**AGENDA**  
**PLANNING COMMISSION**  
**116 WEST NEEDLES**  
**BIXBY, OKLAHOMA**  
**September 15, 2014**                      **6:00 PM**

**To:** Bixby Planning Commission  
**From:** Erik Enyart, AICP, City Planner *EE*  
**Date:** Thursday, September 11, 2014  
**RE:** Report and Recommendations for:  
PUD 12 – Conrad Farms Holdings, LLC &  
PUD 85 – “Conrad Farms” – Conrad Farms Holdings, LLC &  
BZ-377 – Conrad Farms Holdings, LLC

**AS102**

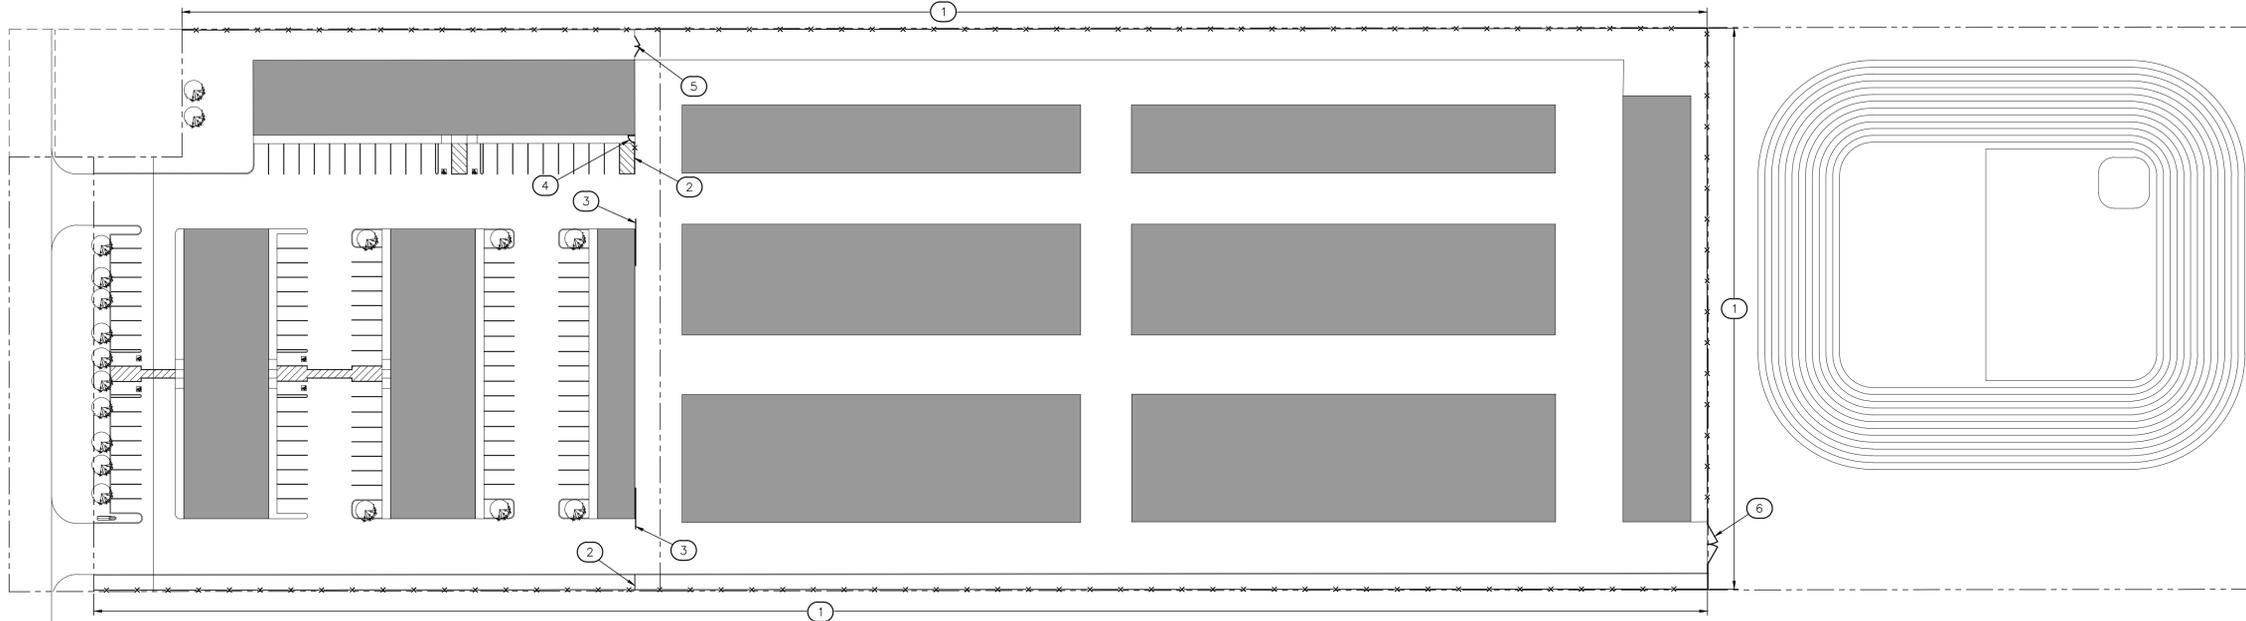
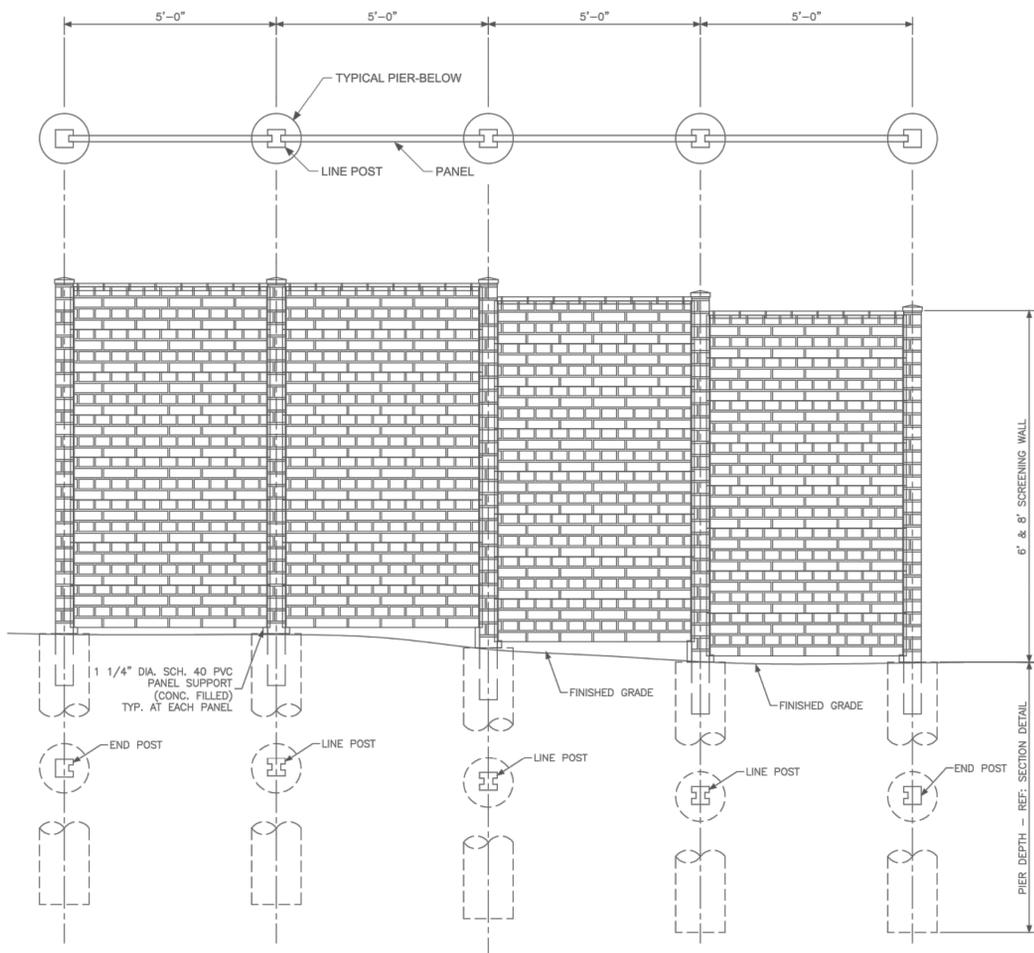
of Reserve A is to keep the City of Bixby's fence in place. A security fence will be installed along the north side of Reserve A, with a gate to allow for access to Reserve A and the detention pond within. These changes need to be made to "Screening Site Plan" drawing AS102.

"Screening Site Plan" drawing AS102 does not represent existing or proposed fences along the property lines shared with the *BTC Broadband* property. This needs to be provided.

"Screening Site Plan" drawing AS102 needs to clarify the extent of the "iron picket fence" separating the office park and ministorage areas.

27. "Screening Site Plan" drawing AS102 needs to be updated to reflect changes to screening plans as amended by the Applicant during the Planning Commission hearing and recommendation of the Final Plat on August 18, 2014 as described in detail in the analysis above.

28. Please represent and label the existing security fence along the boundary shared with the City of Bixby's water tower property, which will remain, on "Screening Site Plan" drawing AS102.

29. "Screening Site Plan" drawing AS102 does not represent existing or proposed fences along the property lines shared with the *BTC Broadband* property. This needs to be provided.

30. "Screening Site Plan" drawing AS102 needs to clarify the extent of the "iron picket fence" separating the office park and ministorage areas.
  31. The site plan does not appear to identify any area(s) for solid waste disposal or mechanical and equipment storage, if the latter are necessary. Such area(s) need to be identified, and plans need to be provided demonstrating compliance with the PUD requirement (enclosure screening height and composition details). Staff respectfully requests a profile view/elevation exhibit be submitted for the Planning Commission's and City Council's review and approval as a part of this Detailed Site Plan.

**ELEVATION - 6' & 8' SCREENING WALL AND PIERS**

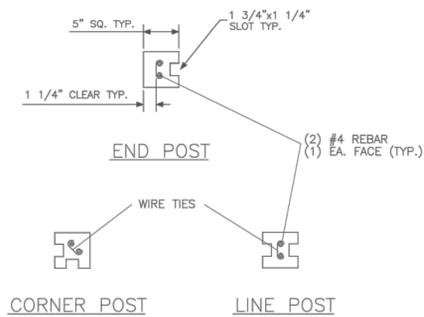
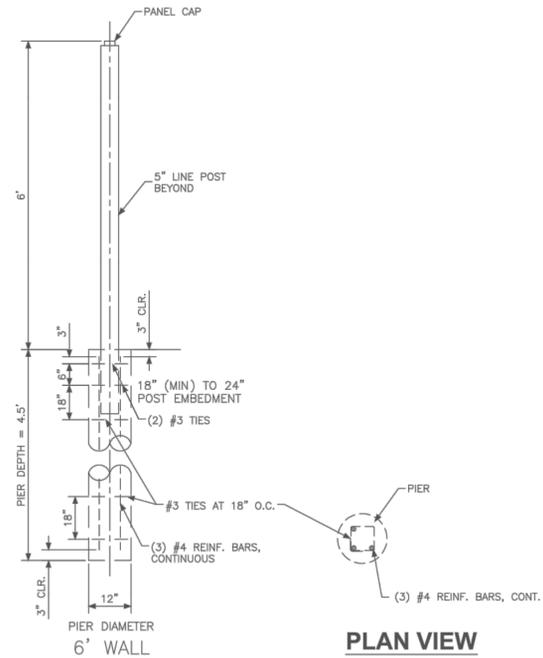
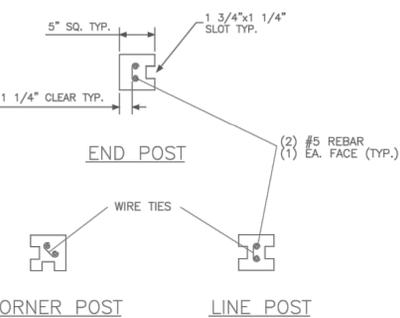
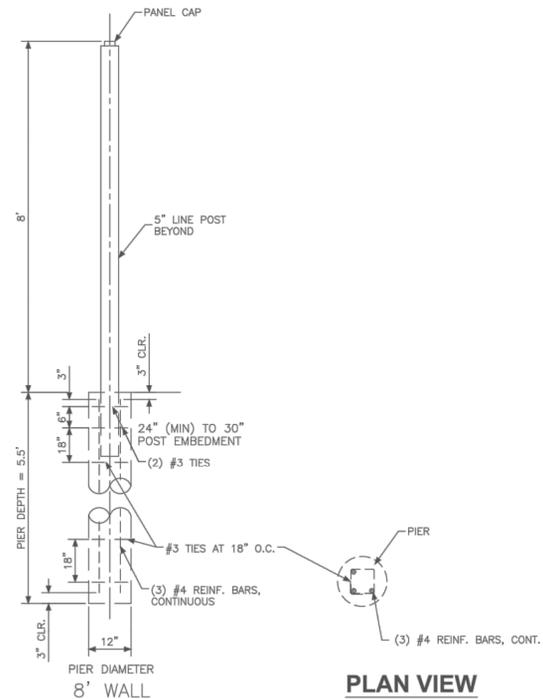
The "Screen Wall Details" drawing AS103 indicates some sections of the screening wall would be 6' in height, rather than 8'. It is not clear from the plans where such 6' height walls would be proposed. All wall sections indicated require the 8' height. The Applicant should reconcile appropriately or advise.

32. The "Screen Wall Details" drawing AS103 indicates some sections of the screening wall would be 6' in height, rather than 8'. It is not clear from the plans where such 6' height walls would be proposed. All wall sections indicated require the 8' height. Please reconcile appropriately or please advise.
